DESIGN 	DRAWN BY 	DART AEROSPACE LTD HAWKESBURY, ONTARIO, CANADA	
CHECKED 	APPROVED 	DRAWING NO. DSI 9239	REV. A SHEET 1 OF 1
DATE 02.08.27		TITLE BASKET MODIFICATION	SCALE NTS
A	02.08.27	NEW ISSUE

## **DART SERVICE INSTRUCTION**

TO AMEND INSTALLATION DRAWING D350-607 REV. E

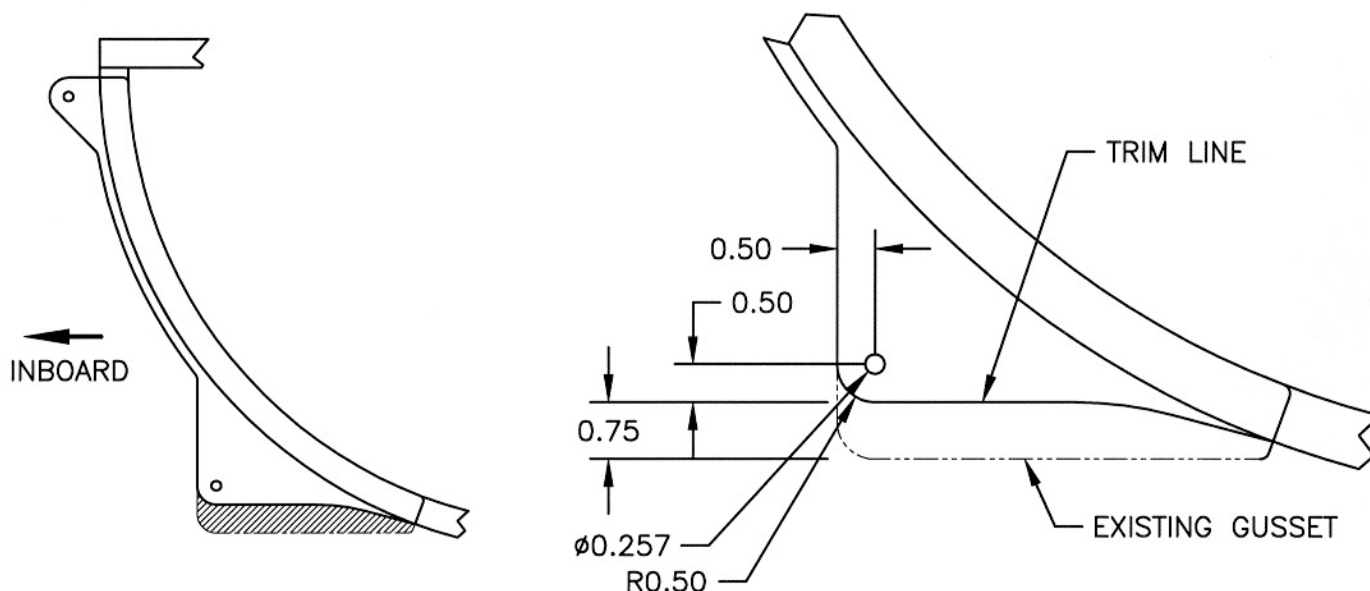
TO IMPROVE COMPATIBILITY WITH OTHER KITS (ie. DART D350-591 STEPS AND D350-600 SPACEPODS), IT IS ACCEPTABLE TO MODIFY THE SUPPORT GUSSETS ON D350-607-041/-042 (CHANGE 005 OR EARLIER) OR D350-607-043/-044 (CHANGE 002 OR EARLIER) AS SHOWN BELOW:

1. REMOVE BASKET FROM AIRCRAFT.
2. TRIM GUSSET AS SHOWN.
3. DRILL  $\varnothing 0.257$  HOLE AS SHOWN.
4. DEBURR AND TOUCH-UP FINISH.
5. REINSTALL BASKET.
